Docket Number:	09-AFC-07C
Project Title:	Palen Solar Power Project - Compliance
TN #:	202773
Document Title:	Staff's Rebuttal Testimony
Description:	N/A
Filer:	Marci Errecart
Organization:	California Energy Commission
Submitter Role:	Commission Staff
Submission Date:	7/18/2014 4:51:59 PM
Docketed Date:	7/18/2014

**RE: ENERGY COMMISSION STAFF REBUTTAL TESTIMONY
PALEN SOLAR ELECTRIC GENERATING SYSTEM
DOCKET NO. (09-AFC-7C)**

Application for Certification for the
**PALEN SOLAR ELECTRIC
GENERATING SYSTEM**

ENERGY COMMISSION STAFF REBUTTAL TESTIMONY

BIOLOGICAL RESOURCES - FIGURE 1
Palen Solar Electric Generating System - Approximate Ivanpah Solar Electric Generating System's Flux Superimposed

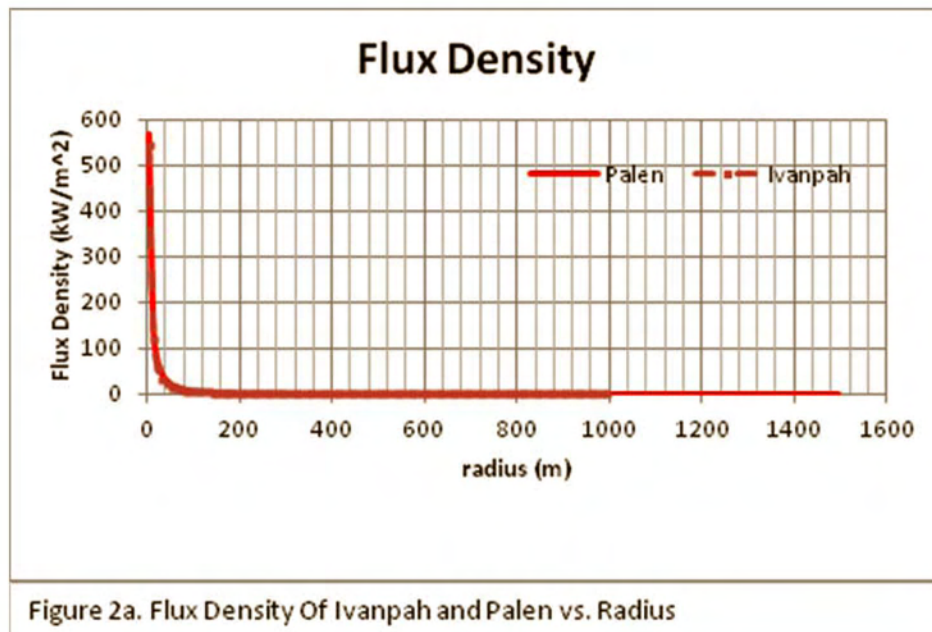
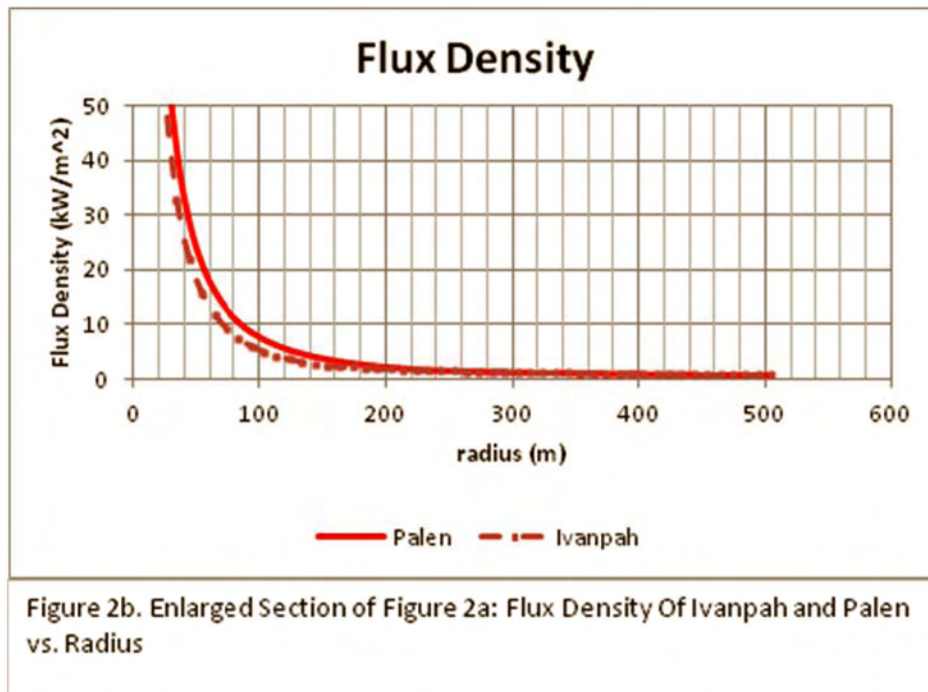
Staff modeled the three dimensional volume of the PSEGS and ISEGS power towers with their representative solar flux fields to illustrate the relative sizes between the two solar power tower plants (see Figure 1). Figure 1, showing a cross-section of one half of each solar field, illustrates that the PSEGS flux field occupies a greater volume and land area relative to the ISEGS flux field.

These are representations of project flux cross sections – the actual flux fields will vary in shape and concentration at any point due to variations in mirror spacing, undulations in terrain, sun angles, etc. Figure 1 starts the inner radius of the mirror field at 240 meters. The installed high density heliostats that range from approximately 150 meters to 240 meters were not modeled for Ivanpah or Palen because the ratio of the areas between the 2 projects will cancel each other out and the flux contributed to the flux field is small when compared to the rest of the heliostat field.

Figure 3. Mortality Distribution of all Birds at ISEGS.

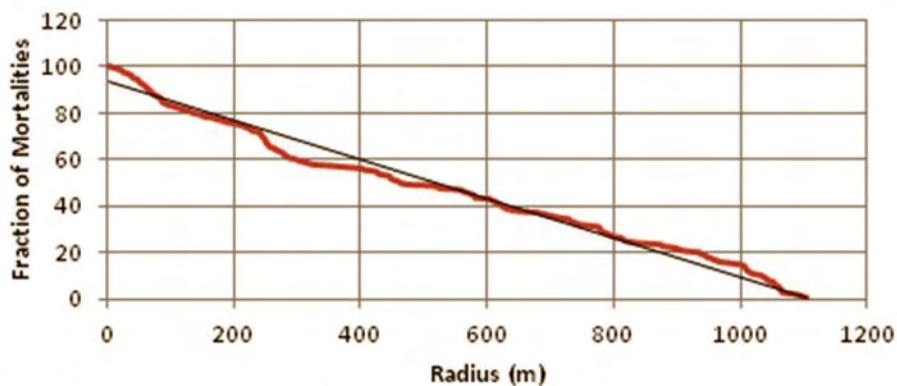
Staff analyzed the collected ISEGS avian mortality data dated from November 27, 2011 through June 9, 2014 – the units were only fluxing later in the period. All of the avian mortality data from each tower was aggregated together to develop a larger dataset for the analysis. Only a small inner area of the site is surveyed 100 percent. The rest of the site is subject to a representative standardized search, where approximately 20 percent of the area is surveyed. The carcass finds outside the inner 100 percent survey zones were multiplied by 5 to account for the partial (20 percent) search zone. The data sets have inherent variability due to searcher efficiency, searcher time period, and search durations for Units 1, 2, and 3. The carcass finds were then graphed against the radius (See Figure 3). The graph illustrated that the carcass finds were increasing with decreasing radius. The carcass finds were then separated into two groups by described features contained in the biologists' notes: visibly singed and non-singed. Accumulations of both of these groups were then graphed against the radius, starting from the outside, of the heliostat field (See Figures 4 and 5).

Figure 4 . Mortality Distribution of Visibly Singed Birds at ISEGS.

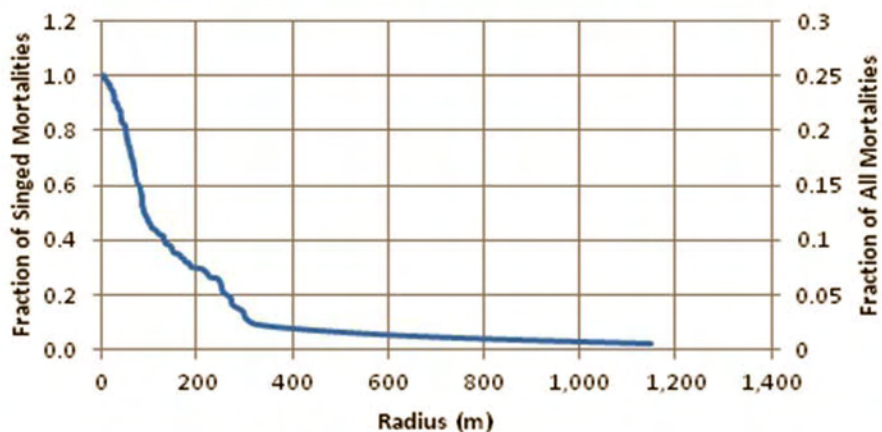
Summing from the outermost mirror row, the accumulated avian mortality of non-singed birds rises linearly with the radius from the outer radius of the heliostat field to the tower. Due to the fairly uniform density of the mirrors, the probability that a bird will hit one of the mirrors in the heliostat field should be about the the same anywhere in the field, and that other non-flux related deaths would be relatively evenly distributed across the project site. This is supported by mortality information for a photovoltaic and a parabolic trough project, and where carcass finds were fairly uniform (i.e., linear relative to position in the field) across the solar array fields.
